**Submission to Standards New Zealand
with regard to
draft Standard DZ 6808:2009
Acoustics – Wind farm noise**

**from
Philip J Dickinson Ph.D., FASA**

Figure 1

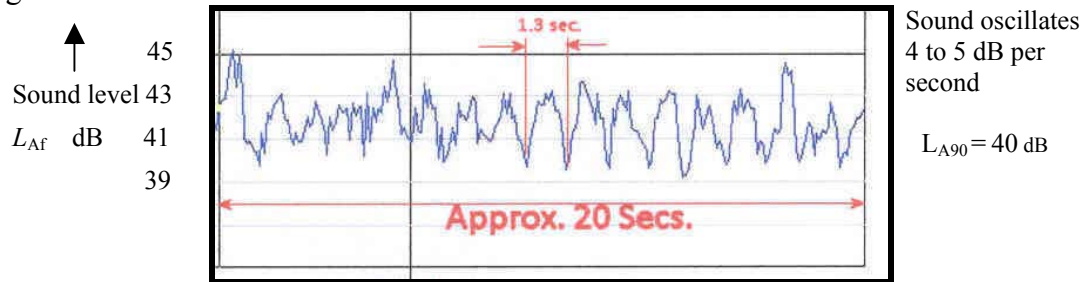
Figure 1 [6] shows a typical windfarm noise time history over a few seconds. The L90 in this case is about 3 dB below the average maximum level (L10) but in many cases it is about 5 dB below. So in many windfarm standards across the world (including this draft) the design criteria is set as an L90 of the background level + 5 dB or 40 dB whichever is greater – again theoretically the maximum one can get away with, without there being very severe repercussions from the community. At such levels there will be severe annoyance, but most people will knuckle down realising that there is almost nothing they can do about it without it costing them quite a lot of money. It does not limit annoyance and it does not protect public health.

Figure 8

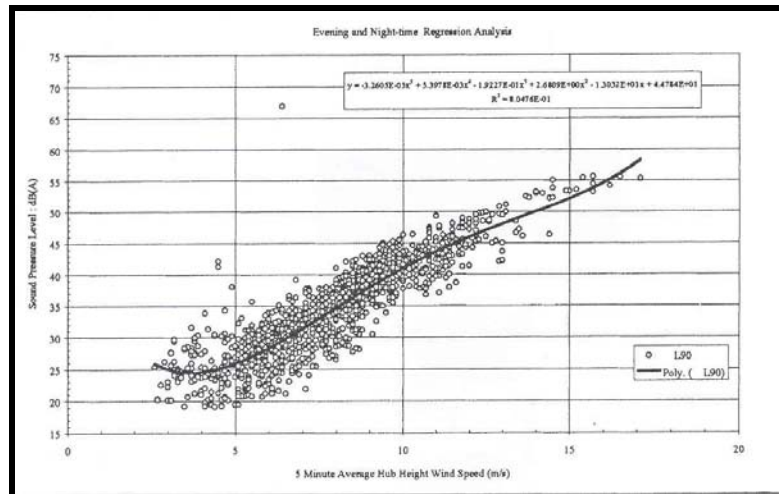
Figure 8 shows a plot of such data pairs as would be produced for a windfarm resource consent [8]

The graph compares a 10 percentile level (L_{A90}) with a linear parameter and then takes a 50 percentile regression line on which to base the alleged relationship between the background sound level at the recipient property with the wind speed at the hub of the turbine which may be on an elevated position some distance away. Not only is there such a wide scatter of data pairs – more than 15 dB on several occasions – but using a 50 percentile regression line for a 10 percentile function rather than a 10 percentile regression line, artificially raises the value of the background sound level and is mathematically incorrect. If such a regression line is to be taken, and the computer program used to analyse the data does not contain the means to use such a regression line, then one standard deviation below the 50 percentile regression line would be nearer the truth.

Figure 9

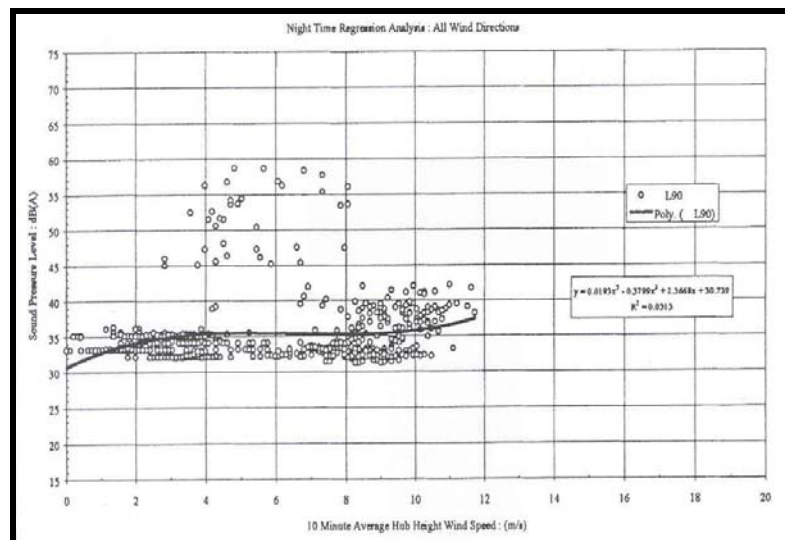
On this graph there is an even greater scatter – more than 20 dB on several occasions – but more worrying is the possibility that the instrumentation used in the unaccompanied monitoring has not truly measured the background sound level at all.

First of all it would appear that the instrumentation did not have a sufficiently low noise floor to record all the sounds at their true level. It will be noticed there is no scatter of results below 32 dB, but tremendous scatter above 40 dB. This suggests the noise floor of the instrumentation used was as high as 32 dB, so anything below 28 dB was recorded as 32 dB or anything between 28 and 32 dB recorded as 33 dB or over. The background sound level may well have been well below 25 dB, even below 20 dB, but the instrumentation has recorded it as being 32 dB. This has artificially raised the value of the background sound level possibly by several dB. It may be noted that some of the equipment seen to be used by noise consultants in New Zealand for such purposes, has this limitation.

Figure 10

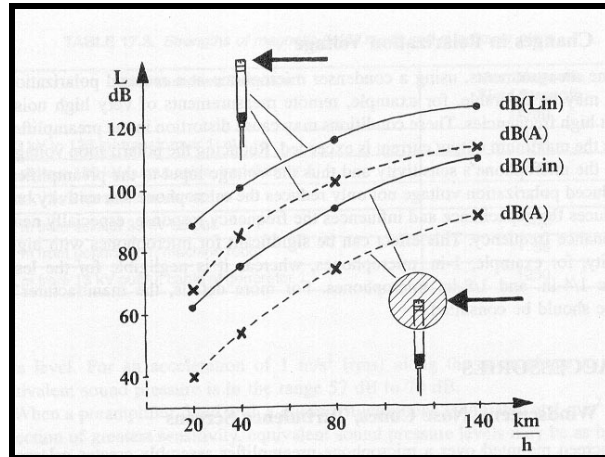
measuring sounds between 30 dB and 40 dB, even with a good windshield in place. Figure 10 below shows the effect of a wind shield on a sound level meter [9]. If the wind at the microphone is 20 km/hr, the sound level meter will register 40 dB without any other sound present even with a windshield in place.

The draft Standard places no limits to the wind speeds in which the measurements are to be taken. If the wind is over 5 metres per second, much of the measurement will be noise from the wind on the microphone and not the background level at all – even with a very good windshield in place. The background sound level is being artificially raised even more – again to the benefit of the noise maker. Such rank manipulations would not be acceptable from any other industry so why is it allowed in the current standard for windfarms and carried over into the new draft? It is mathematically, scientifically and ethically wrong

Figure 13 Sound convection on the wind [16]

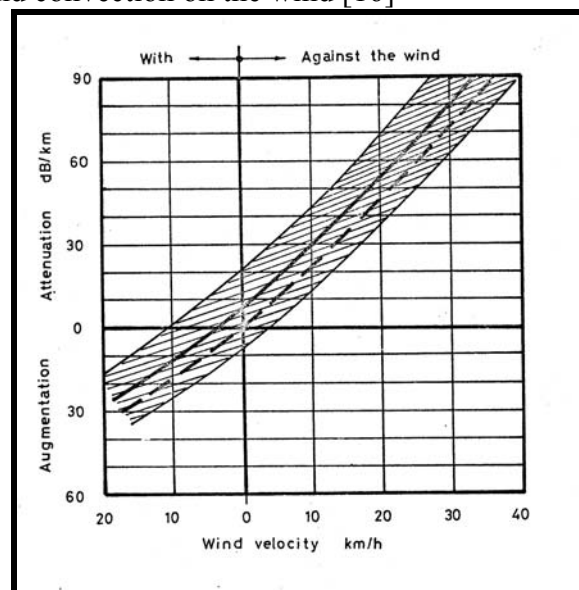
The effect of sound convection by the wind itself Figure 13 has been studied in the past [15] but it is believed has not been included in any prediction methodology, no doubt because the vagaries of the wind flow introduce large uncertainties. Such allowances have to be made if we are to approach reality, but even so as the distances increase so do the uncertainties. Nevertheless, some acknowledgement of sound convection should be made when determining the uncertainties, and allowance made when designing windfarms to conform to public health requirements as recommended by WHO.

The standard should recommend that cylindrical spreading be used for all predictions of sound from a windfarm, but that as the uncertainties are still large, prediction should not come into any part of the conditions that the windfarm has to meet. The conditions should be a fixed level by measurement at any residence (30 dB L_{Aeq}) and how the developers decide this can be achieved, is up to them.
